ADDENDUM NO. 12

PROJECT NO. DGS C-0210-0004 PHASE 001

PROJECT TITLE - PA State Police Greensburg - DNA Laboratory Facility New Building

ADDENDUM 12

SHAPE DRAWING
 3" x 1" OR 5" x 1" CMP PIPE ARCH
 66" EQ DIA 73"x55"

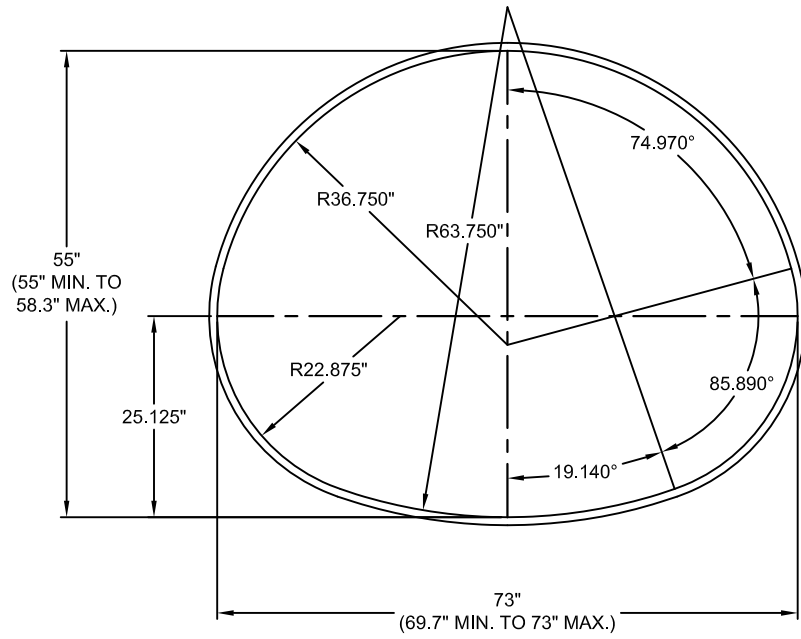
Item	Description
Item 1	The RFI response spreadsheet in Addendum 11 was missing the last page and a half. Attached is the corrected spreadsheet with the missing responses.
Item 2	Also missing were the details and design guide for the response to .1 contract RFI 42, regarding the metal arch culvert. The are attached to this addendum.

.1 Contract - RFI 41	11.03.2022 10:34 AM	JR Bittner, Rycon Construction, Inc.	Ceiling Details: Open Office 200/Corridor 216—There are no details indicated on how to transition from ACT1, ACT2 and ACT3A Data Base Open Office 218 does not have Gyp Board Ceiling Heights or a detail showing the transition from Gyp Bd to ACT 2. It appears there are 6" pieces of ACT 2 as well. These ceilings are very complex and we need more details.	Details for the transition are on Sheet A831, but were mistakenly not referenced on the ceiling plan. The applicable detail between ACT 1 and ACT 2 is 1/A831. The applicable detail between both ACT 1 and ACT 2, and ACT 3A, is also 1/A831.	11.14.2022
.1 Contract - RFI 42	11.03.2022 11:54 AM	Ron Smith, DiMarco Construction Co. Inc	Earthwork: For the metal arch culvert, we are not seeing a detail for that. Does one exist?	A standard detail and design guide for the 73" x 55" CMP pipe arch will be attached to this addendum.	11.14.2022
